## 9.5 Other Auxiliary Systems

The information in this section of the reference ABWR DCD, including all subsections, tables, and figures, as modified by the STP Nuclear Operating Company Application to Amend the Design Certification rule for the U.S. Advanced Boiling Water Reactor (ABWR), "ABWR STP Aircraft Impact Assessment (AIA) Amendment Revision 3," dated September 23, 2010 is incorporated by reference with the following departures and supplements.

STD DEP T1 3.4-1	STD DEP 9.5-2 (Figure 9.5-3, replaced entire figure)
STP DEP 1.1-2 (Figures 9.5-2, 9.5-4 and 9.5-5)	STD DEP 9.5-3
STP DEP 1.2-2 (Table 9.5-5)	STD DEP 9.5-4
STD DEP 8.3-1	STP DEP 9.5-6 (Figure 9.5-6)
STD DEP 9.4-2 (Table 9.5-5)	STP DEP 9.5-7 (Table 9.5-5)
STD DEP 9.5-1	STD DEP Admin

Figure 9.5-4 Fire Protection Water Supply System

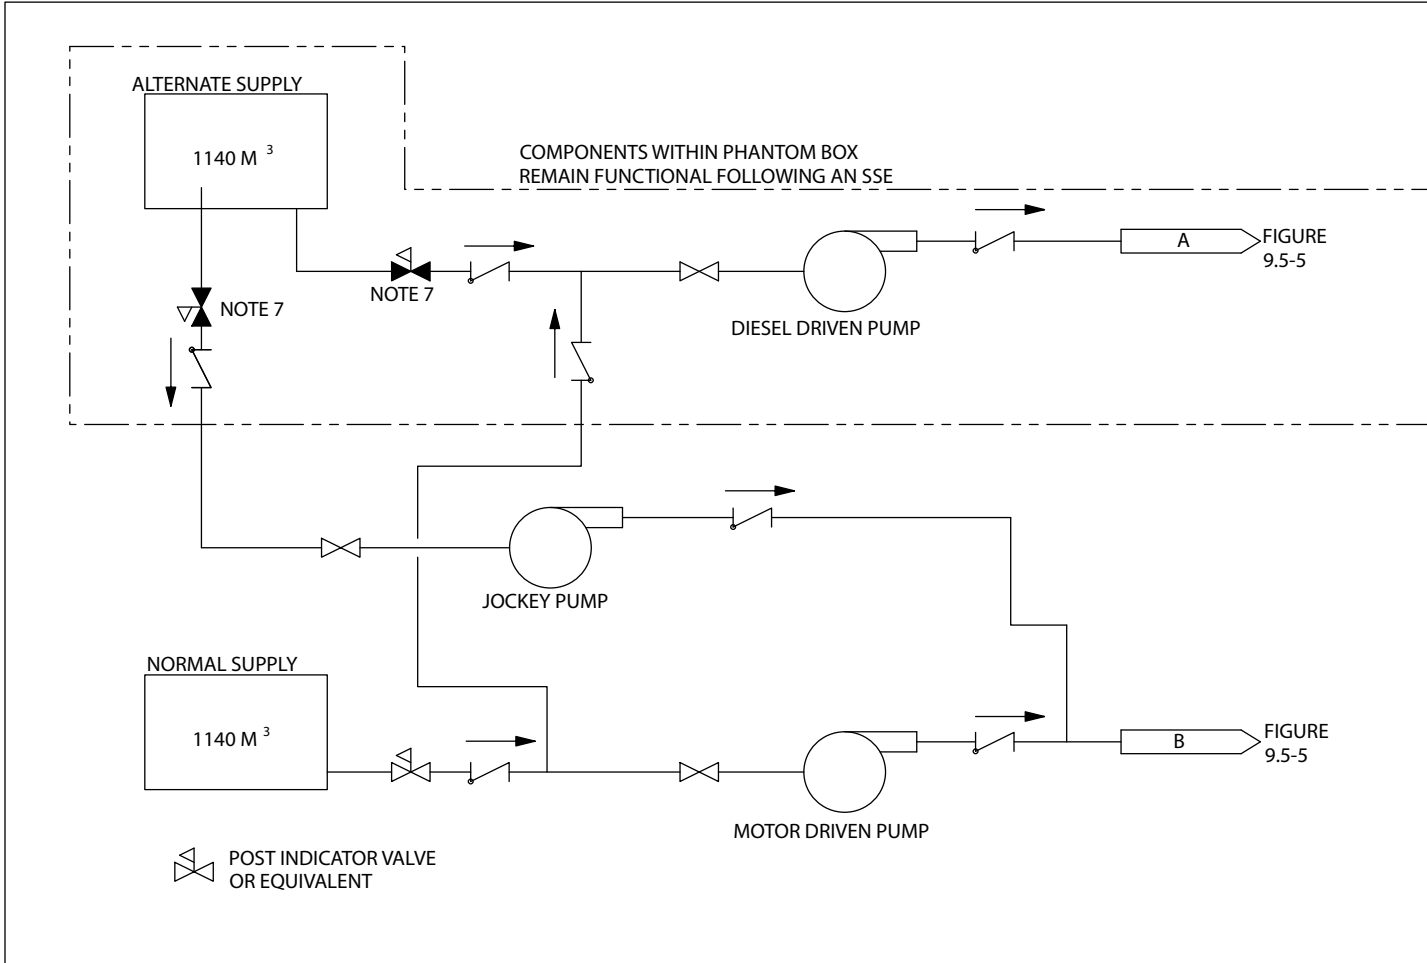
STP 3 & 4 is a dual-unit station. The water supply for fire protection will be shared by STP 3 & 4. A single fire protection pump house and two storage tanks are located within the protected area boundary that provides water for fire suppression to both units via piping in the yard. This common system has the same capability as the system for the single unit design. The fire protection water supply complies with Regulatory Guide 1.189, Rev. 1, which states that a common water supply may be utilized for multi-unit nuclear power plant sites with a common yard fire main loop. The common fire water supply and yard main piping system for STP Units 3 & 4 are depicted in Figures 9.5-4 and 9.5-5. The common yard fire main loop surrounding STP Units 3 & 4 is cross-connected between units in accordance with Regulatory Guide 1.189, Rev. 1.

Figure 9.5-5 Fire Protection Yard Main Piping

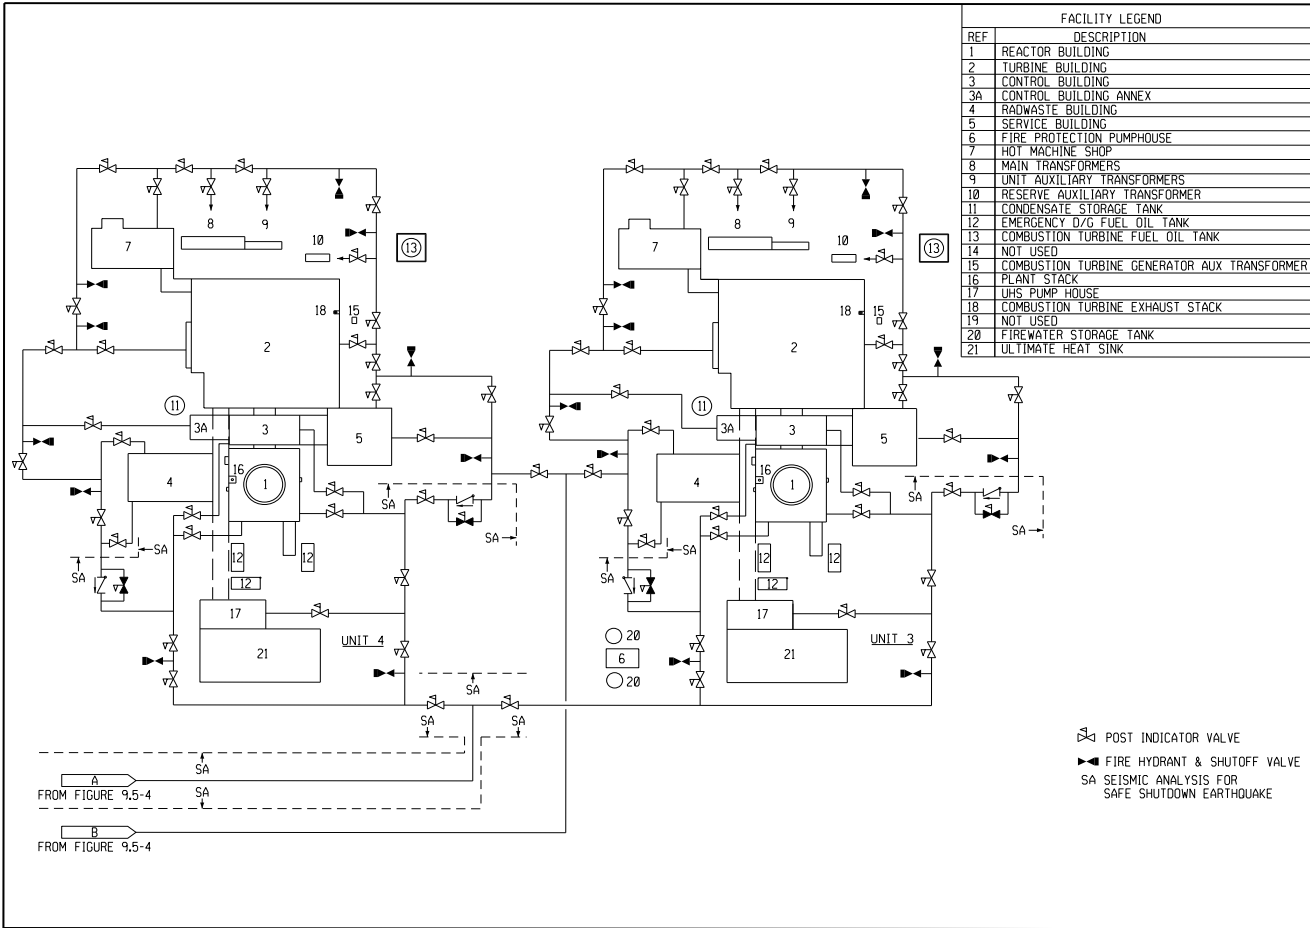
<i>Area</i>	<i>Figures</i>
<i>Reactor Building</i>	<i>9A.4-1 thru 9A.4-10</i>
<i>Control Building</i>	<i>9A.4-11 thru 9A.4-16</i>
<i>Turbine Building</i>	<i>9A.4-17 thru 9A.4-21, <u>9A.4-33 and 9A.4-34</u></i>
<i>Service Building</i>	<i>9A.4-22 thru 9A.4-27</i>
<i>Radwaste Building</i>	<i>9A.4-28 thru 9A.4-32</i>
<i>Plant Yard</i>	<i>9.5-5</i>
